FIRE SAFETY INSPECTION REPORT

M.I.M. FASHION WEAR LTD.

ACCORD ID: 12288

October 18, 2015

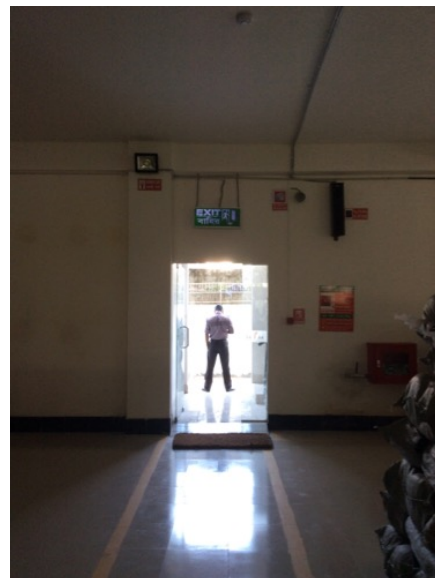
F-3	Fire Rated Construction	Areas used for combustible storage on ground floor open to the factory are not properly defined and/or not within limits.	Provide defined storage areas and limit the storage arrangement as follows: - Maximum height of 2.45m (8 ft) and maximum area of 23m ² (250 ft ²) Separate areas of unenclosed combustible storage by a minimum clear distance of 3m (10 ft).	Within 3 months
-----	-------------------------	---	--	-----------------

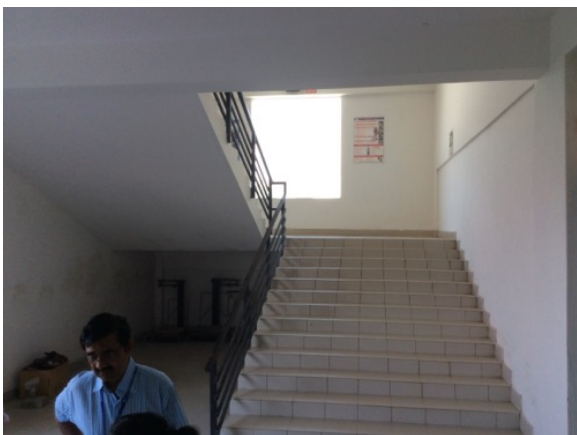
F-4	Fire Rated Construction	The boiler room is not separated by fire-rated construction due to non-rated door.	Separate the boiler room by a minimum 1-hr fire-rated construction for non-high rise. Seal and/or protect all openings to maintain the required fire separations. Provide proper ventilation and consult a qualified engineer.	Within 3 months
-----	-------------------------	--	--	-----------------

When located to the exterior of a building, separate the boiler by a minimum distance of 3m (10 ft).
